Withlacoochee River Watershed Initiative Peer Review

September 2020

Singhofen & Associates, Inc. (SAI) was contracted by SWFWMD to conduct a Peer Review of several models including existing-condition and various scenario models. The review also included supporting data (GIS files, reports, etc.) developed for the Withlacoochee River Watershed Initiative (WRWI).

Figure 3.1 – Breakline to Improve Accounting for Conveyance

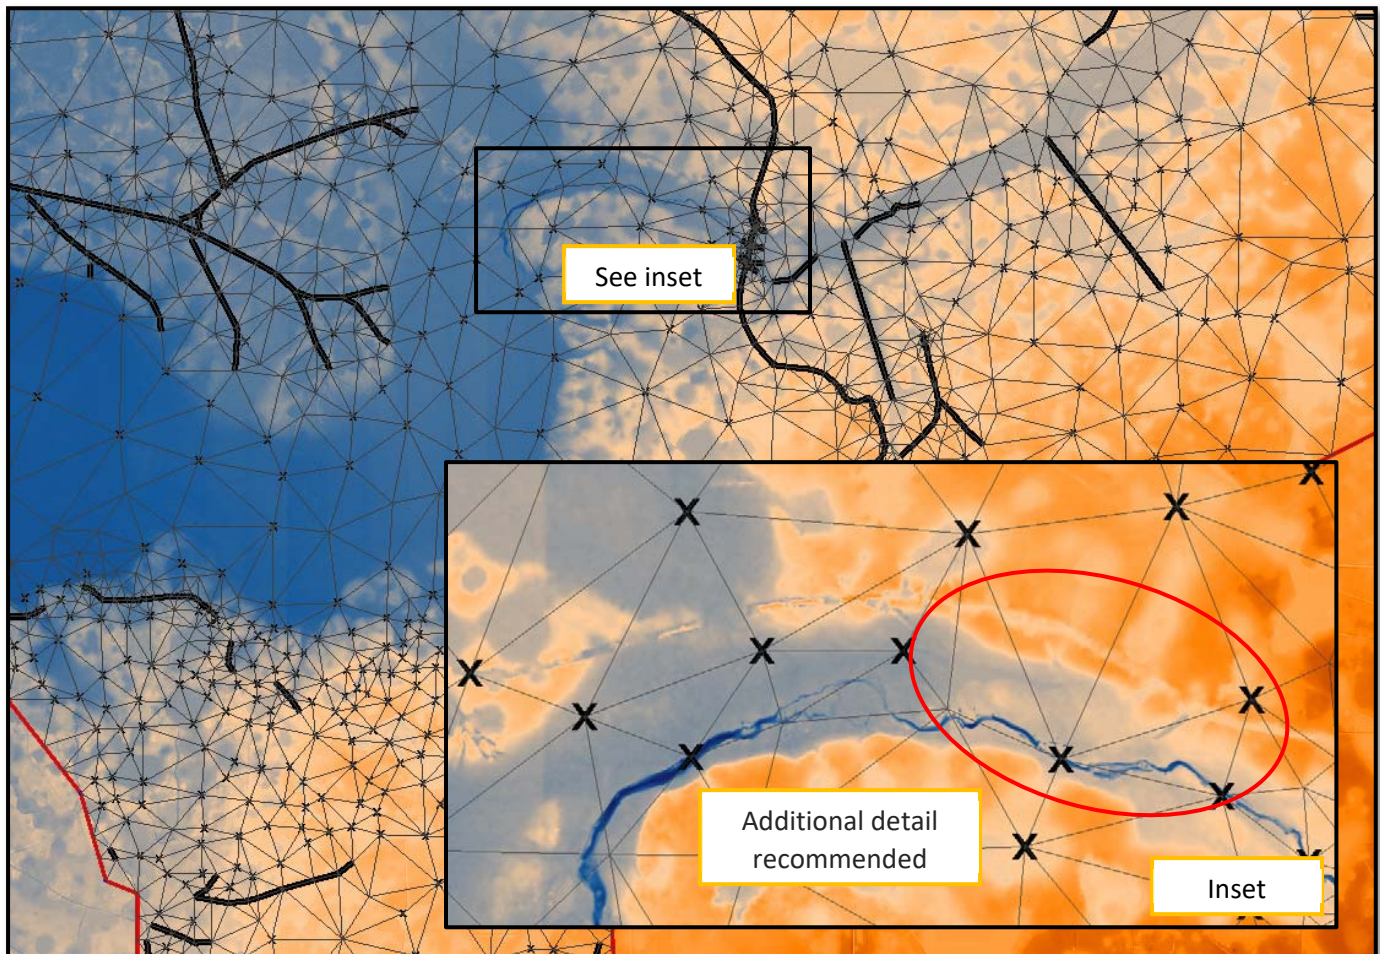
3.1.1 Breakline and 2D Mesh: **Figure 3.1** shows a location at which some additional breaklines or breakpoints could be used to create a more accurate mesh along a stream system. There is a stream flowing from east to west which then turns south. Break points were placed to generate 2D links along the thalweg, however, additional points or breaklines could have been placed along the bank and bottom of slope to better define conveyance in this small area similar to the approach used along the stream to the east and west. The issue is generally limited to the east-west portion of the stream, just west of a road crossing. After the stream turns south, the terrain “opens up” and the mesh is reasonable. Adjustments at this location would result in a localized change in stages but would not be expected to propagate far from this area.

Figure 3.2 – Breakline to Account for Ridge and Prevent Short-circuit Flow

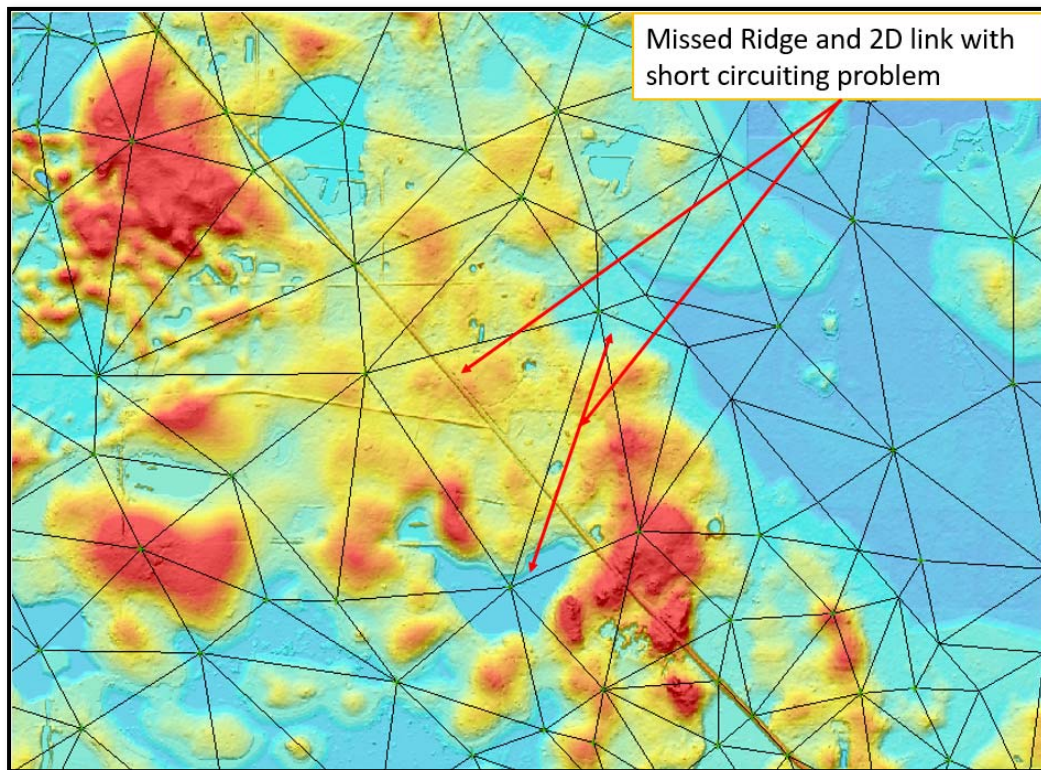
Figure 3.2 shows a location where the mesh “misses” a ridge/road creating a short-circuiting link between a large wetland system and isolated depression. Use of a breakline along the road would correct the problem. Overflow from the southern depression, however, is to the south and is well-configured.

Figure 3.3 – Pond Control Volume to Account for Offline Storage

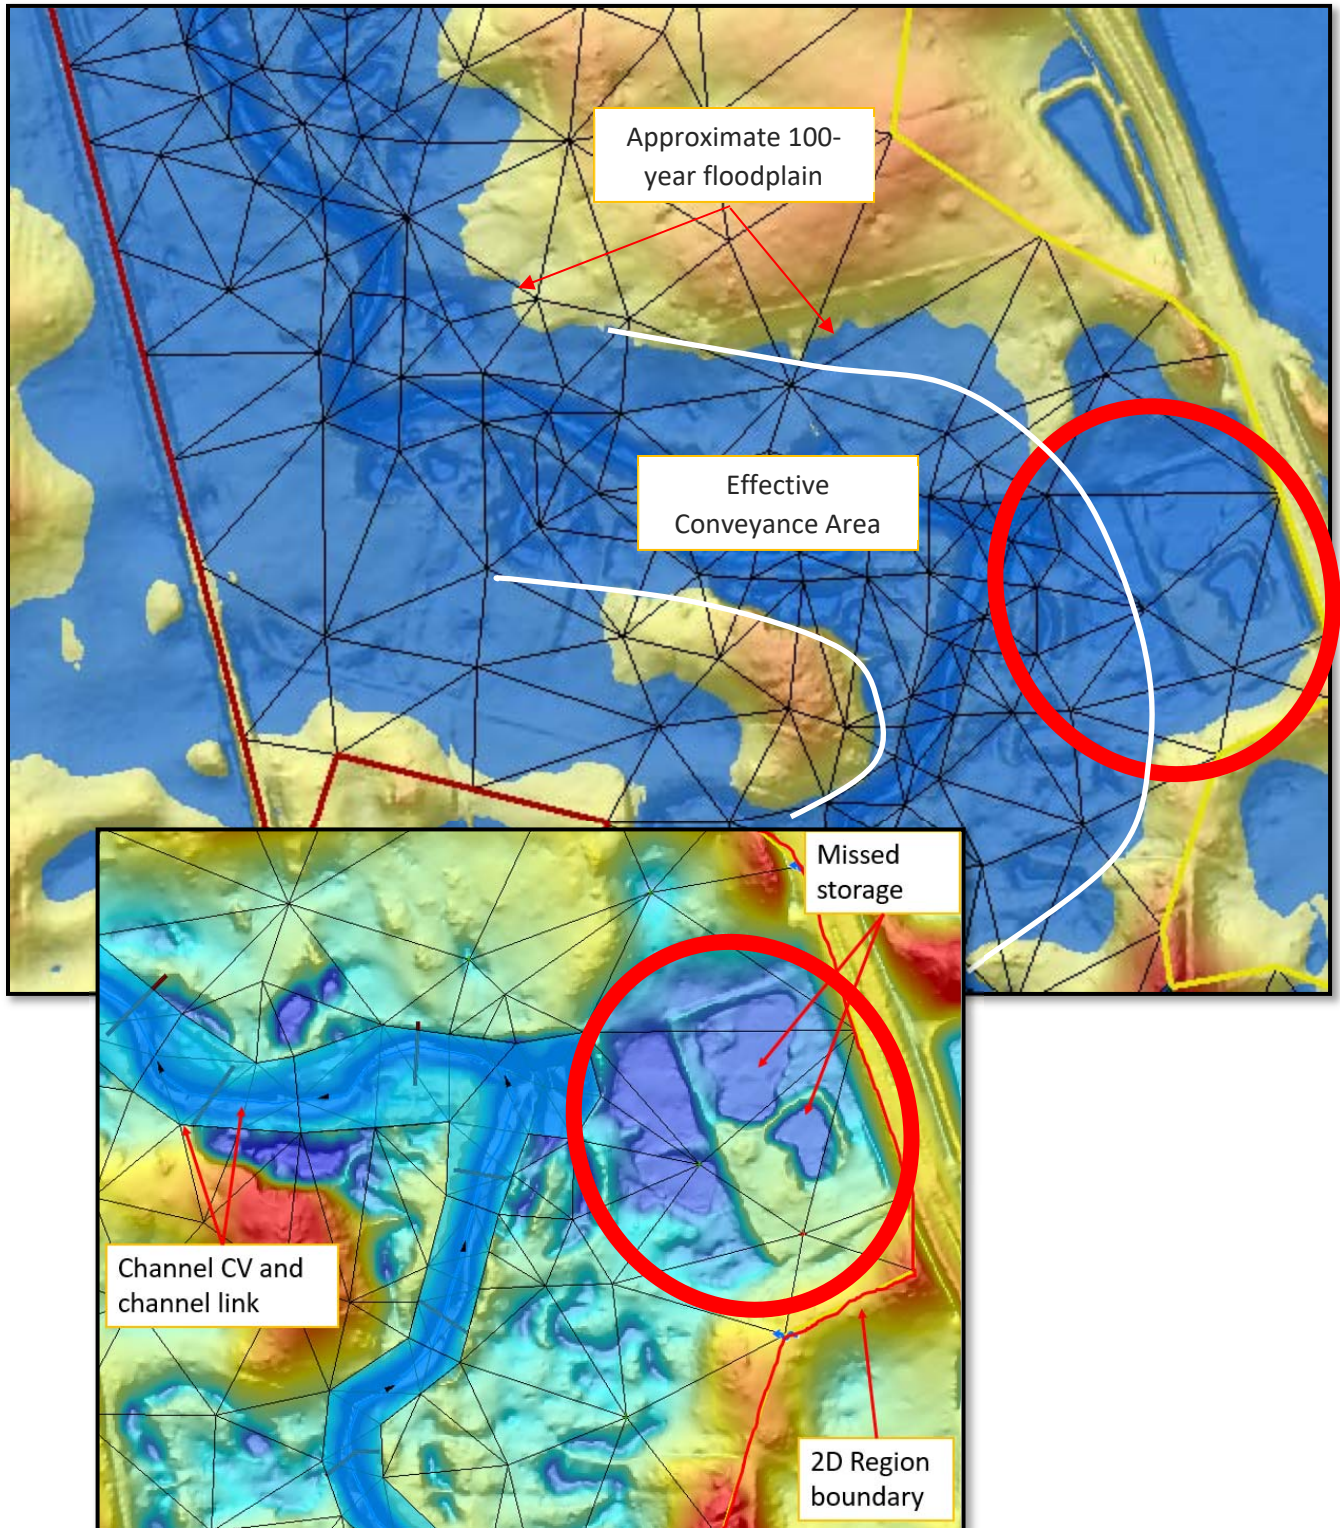
3.1.2 Pond Control Volume: **Figure 3.3** shows a couple of small ponds or depressional areas located adjacent to the river. The mesh generation did not result in placement of sufficient 2D nodes to represent all storage in that area. A more accurate approach would be to include a pond control volume feature to account for the offline storage along the channel. This feature would also tend to enhance model computational efficiency through increased node stability.

With that said, this area of the river is relatively narrow and accurate accounting for conveyance is key to modeling conditions through this reach. The mesh is reasonably configured to account for conveyance along this portion of the river. Additionally, some of the storage is accounted for in the mesh. As a result, while addition of a pond control volume would provide a bit more accuracy in the results, the modification would only yield a localized impact to staging in this area and would have minimal impacts to conditions upstream or downstream of this area.

Figure 3.4 – Cove Feature to Account for Offline Storage

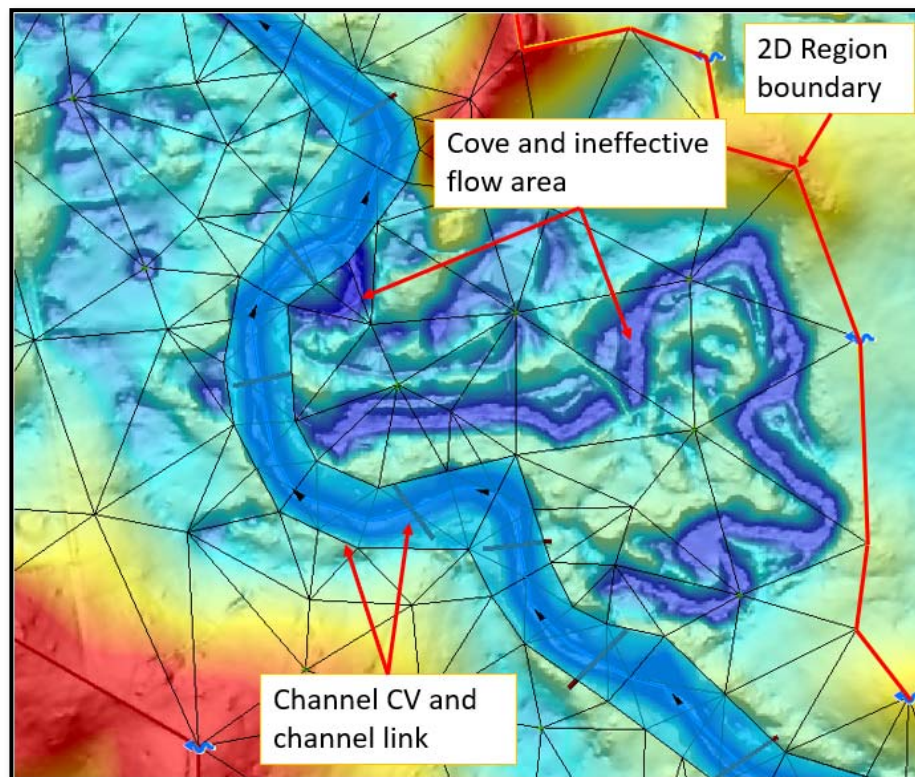
3.1.3 Cove Features: ICPRv4 includes a Cove feature to account for offline storage in ineffective flow areas along a channel. The cove feature is associated with the channel control volume and provides level pool storage at that location. Addition of a cove feature also helps improve stability at the channel and offline storage interface. **Figure 3.4** shows an area in the 2D mesh just south of the location mentioned above that would be better represented using a cove. This location includes an oxbow area of the stream along the main channel. It is not completely represented by the mesh. Use of a cove would allow more accurate accounting of the oxbow storage. With that said, this change would not significantly affect conveyance at this location and would, therefore, result in localized stage changes only.

Figure 3.5 – Example of External Hydrograph Discharge Points

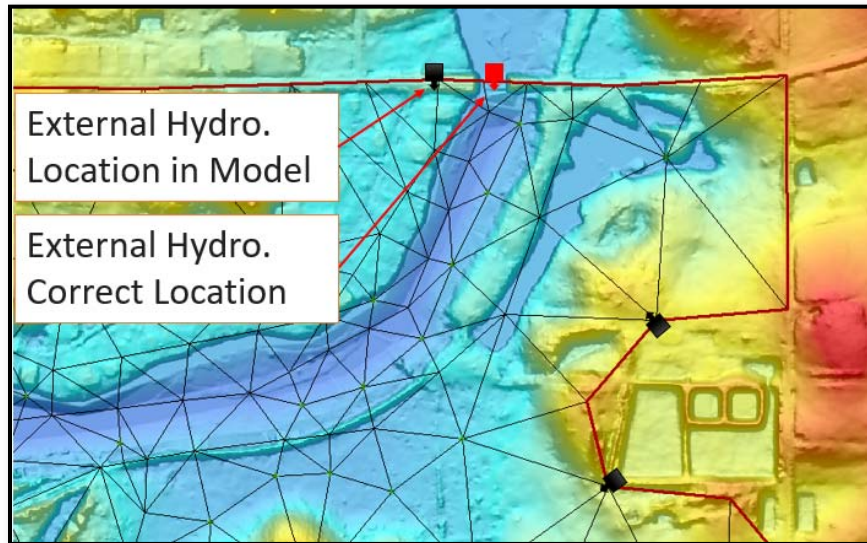
3.1.4 External Hydrograph Inflow: As mentioned, the peer review scope was limited to 2D model areas. Detailed and Approximate study areas were not included. With that said, SAI did review locations where flows from those study areas were assigned within the 2D mesh. The review did not identify significant problems. It is noted, however, that inflow points at some locations are placed on top of a berm or roadway rather than immediately adjacent to or at the stream (See **Figure 3.5**). This could result in some overland flow through upland mesh area before reaching the intended adjacent stream. While potentially problematic at the inflow point, this is not likely to be an issue locally or over the watershed.

Figure 3.6 – Cumulation Rainfall and Actual Evaporation for the Verification Storm

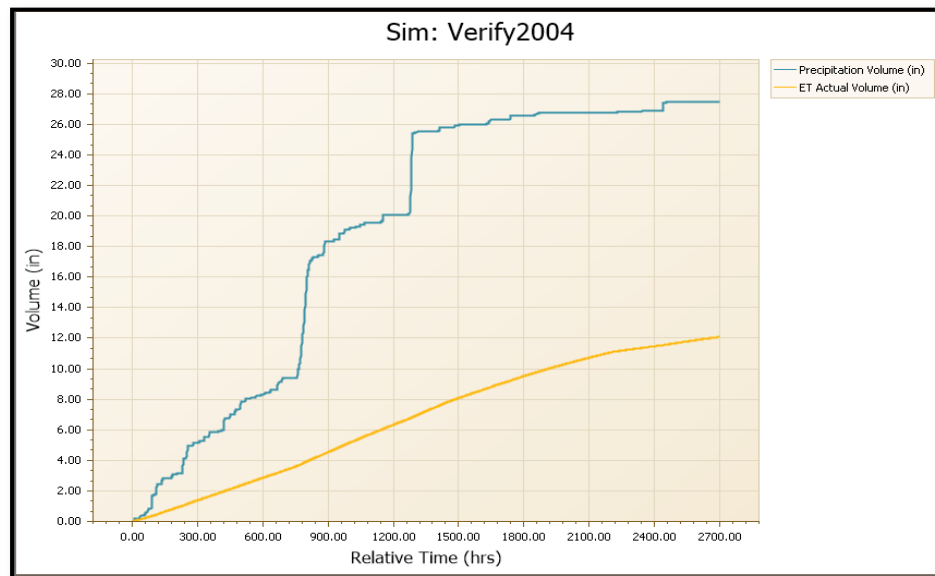
The model incorporates evapotranspiration (ET), however, the source of ET data is not clear. A full review of the ET implementation was not possible as the original modeling was performed using an early version of ICPR. With that said, SAI was able to review model results and determine the ET data used were not obtained from USGS data. Figure 3.6 shows the evaporation simulated in the model versus total cumulative rainfall during the verification storm. This information was obtained from the model output data. Based on the results, total evaporation for the full period of the simulation was about 12" which is about 40 percent of the total rainfall. This value represents approximately 0.11" of ET per day, which is a reasonable value for this area according to available USGS data. Given the success of the verification model simulations, implementation of ET in the modeling appears accurate.

Figure 3.7 – Channel with Significant Bedslope (Channel_4777)

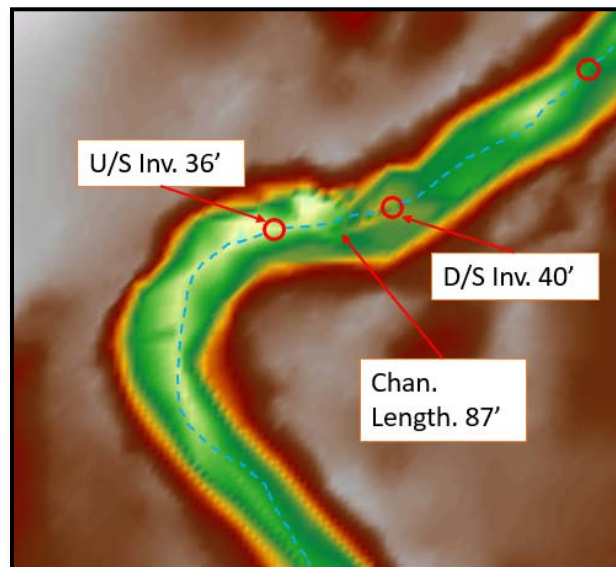
Channels with bedslopes in excess of 2.5% were identified. Just one channel was found with a 4.5% bedslope (Channel_4777). SAI reviewed the DEM for this channel, and it appears that there is a large natural elevation change at this channel location. This slope appears reasonable (**Figure 3.7**).

Figure 4.1 – Example Initial Stage in Node Hydrograph (Verification Storm 2004)

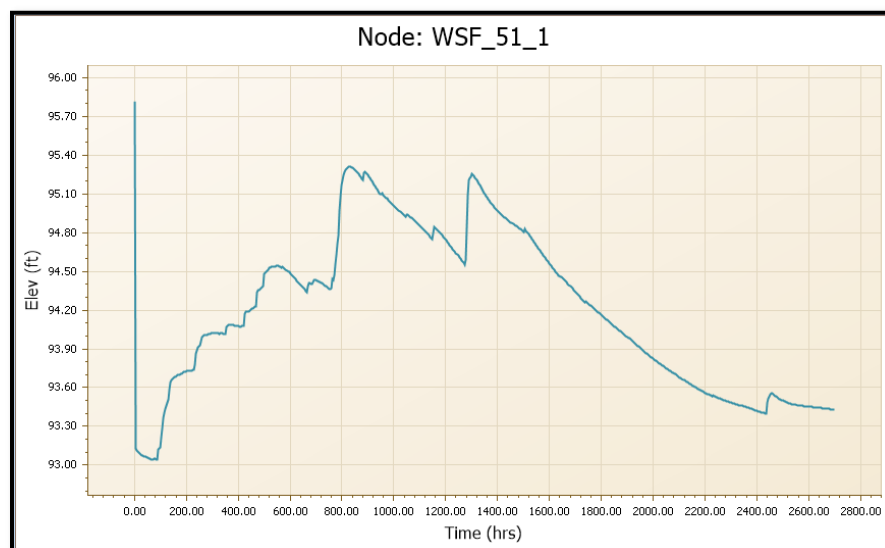
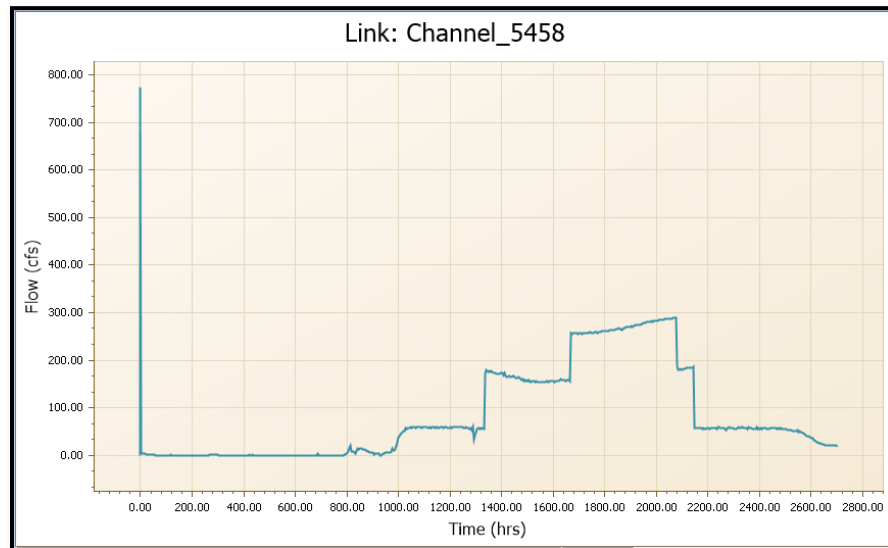
Figures 4.1 and 4.2 show an example of initial stage and initial flow problems, respectively. The problem is short, temporary, and is spatially confined to the immediate vicinity of the interface nodes and does not affect overall model results.

Figure 4.4 – Instability Example: Link: Channel_4554 - Flow and Stage Graph

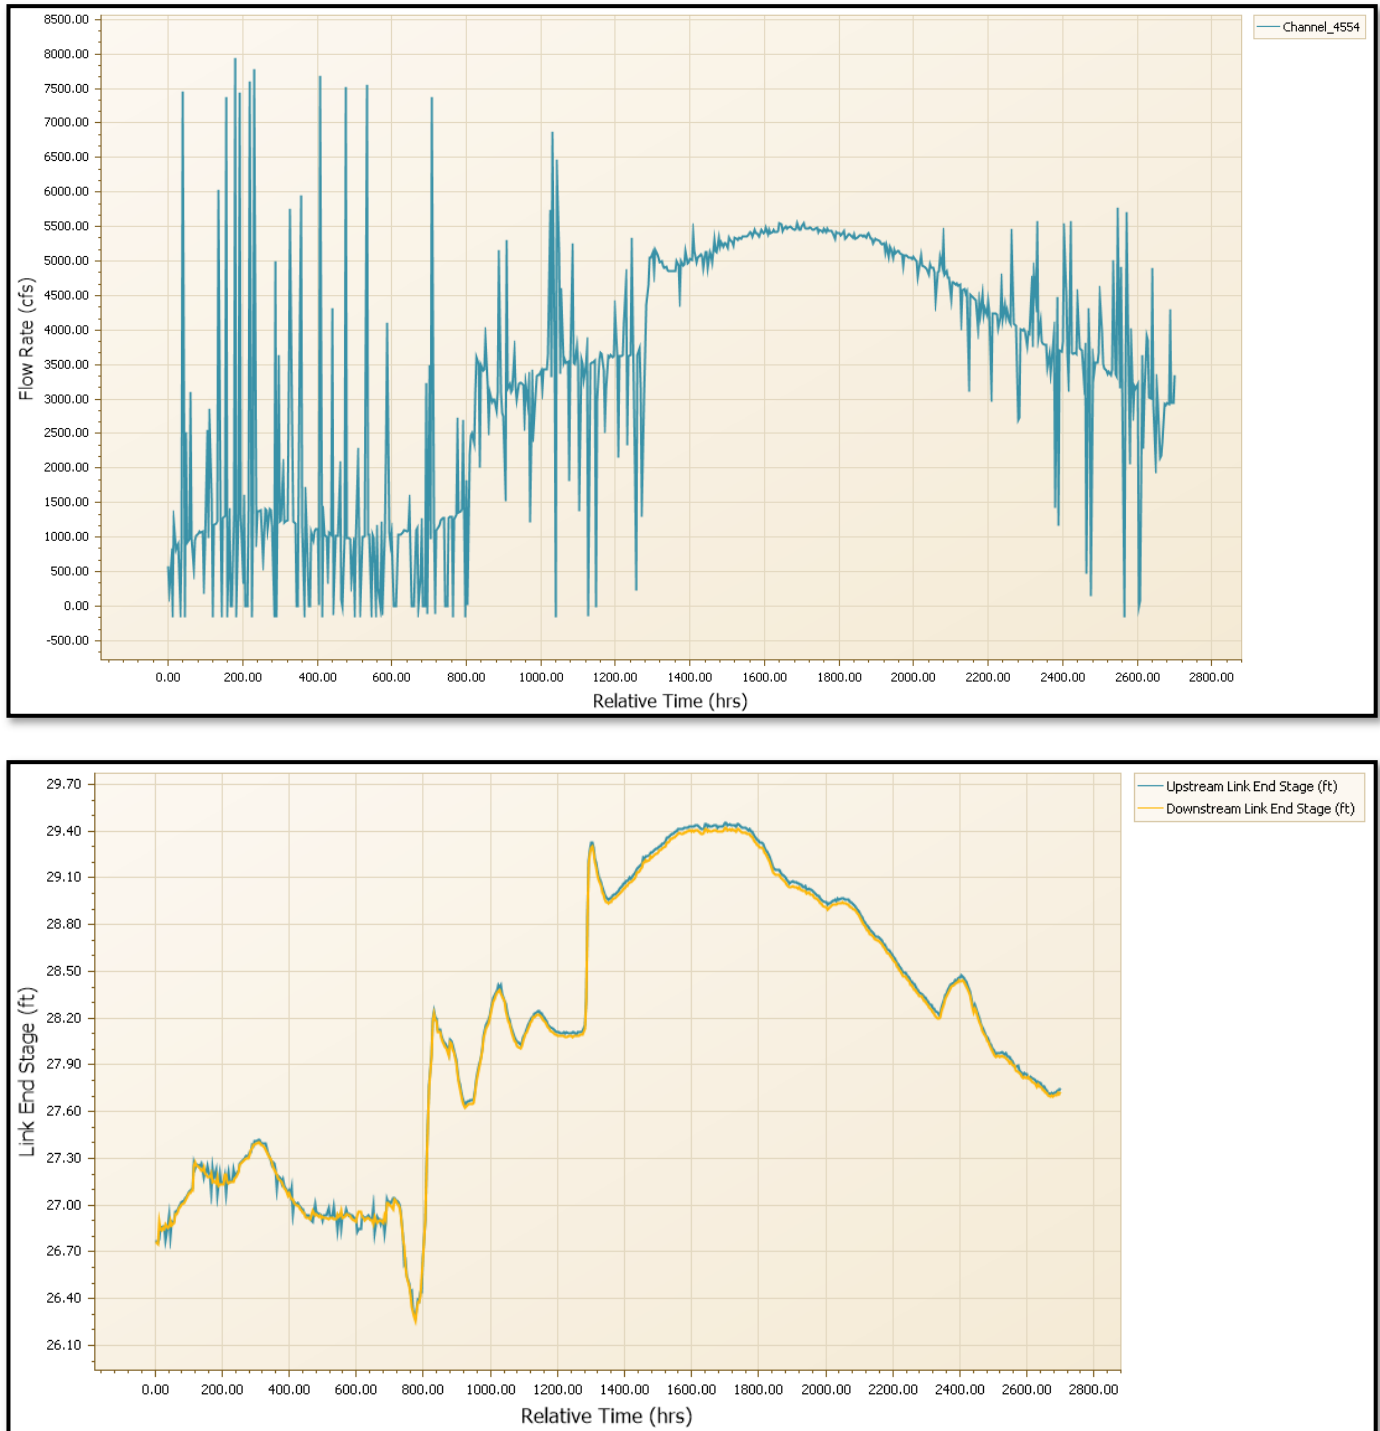
[Figure 4.4](#) shows an example of channel link instability noted in the model. This location is in the area of US 41, a short distance upstream of Lake Rousseau. As shown in the figure, some surging is noted in flow during low water conditions. Those surges have a relatively small impact on node stages. As flood stages and flow rates increase to peak conditions, the instability is reduced or eliminated, and flood stages are stable. The stability issue is spatially limited to the short reaches through this general area. Flow rates in the longer reaches upstream and downstream of this location are stable during the entire simulation.
